**SEQUOYAH NUCLEAR PLANT (SQN) - REVISED RESPONSES TO NRC
QUESTIONS 1, 2, and 3 FOR TECHNICAL SPECIFICATION (TS) CHANGE
00-14, "PRESSURE TEMPERATURE LIMITS REPORT (PTLR) AND REVISED
TOPICAL REPORT (WCAP-15984, REVISION 1), REACTOR CLOSURE
HEAD/VESSEL FLANGE REQUIREMENTS EVALUATION FOR SEQUOYAH UNITS
1 AND 2" (TAC NOS. MB6436 AND MB6437)**

SEQUOYAH NUCLEAR PLANT (SQN) REVISED RESPONSES TO NRC QUESTIONS 1, 2, AND 3

TECHNICAL SPECIFICATION (TS) CHANGE NO. 00-14, DOCKET NOS. 50-327 AND 50-328

Figure 1-1 Finite Element Model for Closure Head Region, Sequoyah Units 1 and 2

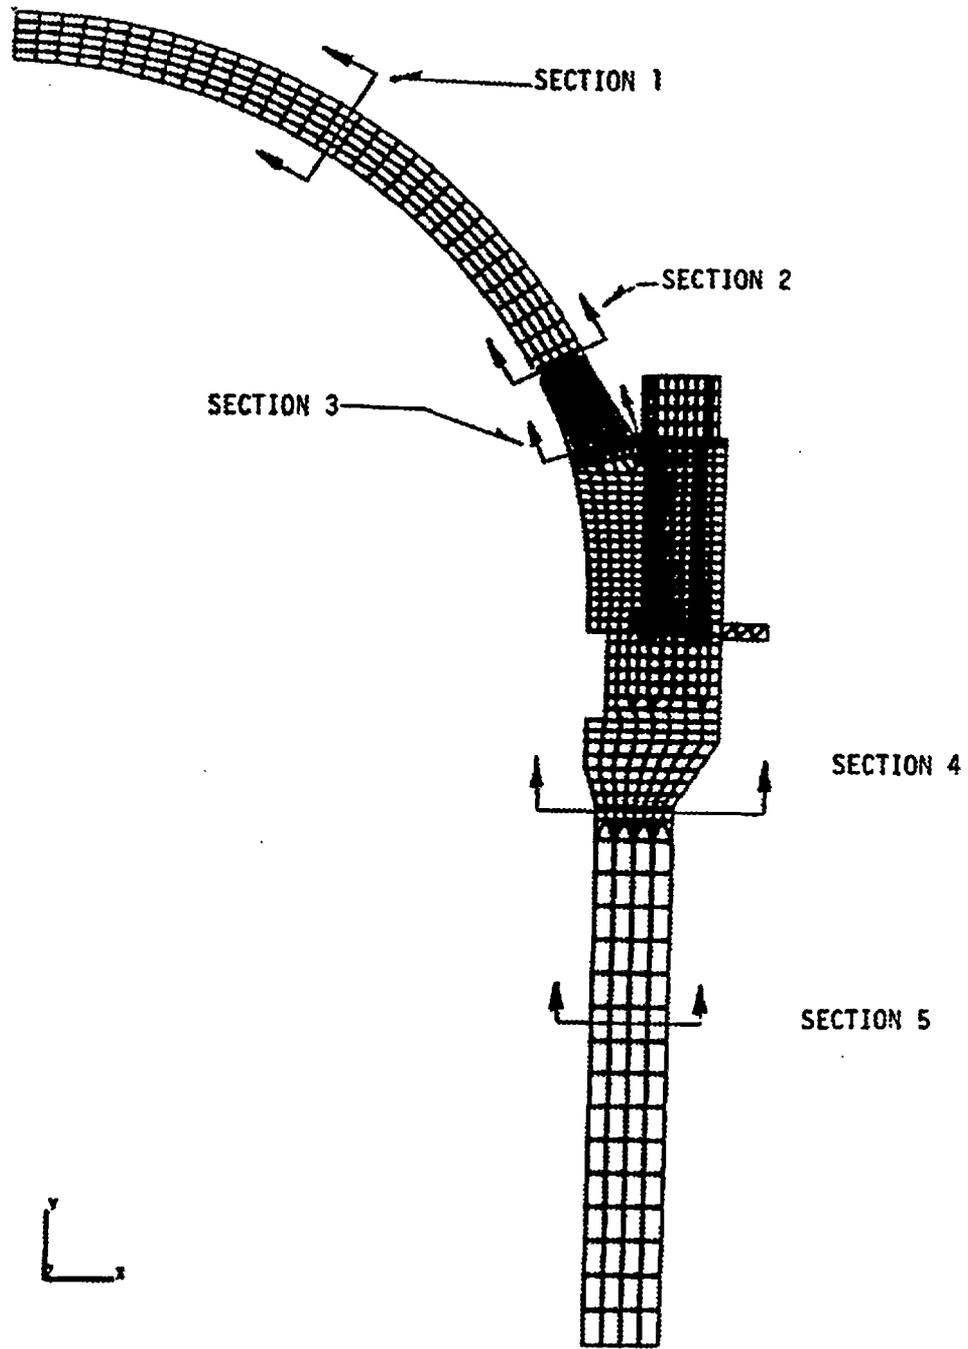
Regarding the discussion on page 4-1, "These results [the stresses for boltup and steady-state operation given in Table 4-1] were taken from a finite element analysis of the heatup/cooldown process, and the boltup was determined to be the most limiting time step for the entire heatup/cooldown transient."

Provide a summary which identifies how the finite element analysis (FEA) was performed, including important analysis variables (e.g., mesh size/element used, convergence criteria, thermal transient time step magnitude, boundary conditions, etc.). The level of detail provided should be such that the U.S. Nuclear Regulatory Commission (NRC) staff will have reasonable assurance regarding the acceptability of the licensee's FEA process and input variables. Provide stress analysis results consistent with the level of detail provided in Table 4-1) and through wall temperature distributions at twenty evenly distributed points along the most limiting heatup/cooldown transient which was analyzed.

The stress analysis was performed using an axisymmetric model shown in the cross section in Figure 1-1, where the cross section of interest is highlighted as Section 3.

Physically, the reactor vessel shell will displace laterally, and the crown of the head does not displace laterally. To approximate this behavior, the bottom surface of the model in the shell region and the vertical surface of the model at the vessel crown were both assumed to be resting on rollers. This arrangement of restraint is assumed to correspond to the actual behavior of the vessel and prevents any rigid body motion of the model.

Choosing to couple mechanically at only the pivot location, as discussed above, should tend to increase the bending stresses at all the selected Sections 1 through 5 shown on Figure 1-1. Mechanical coupling at more than one node, or all the nodes on the flange mating surface would have prevented free rotation of the flanges and reduced the bending stresses.
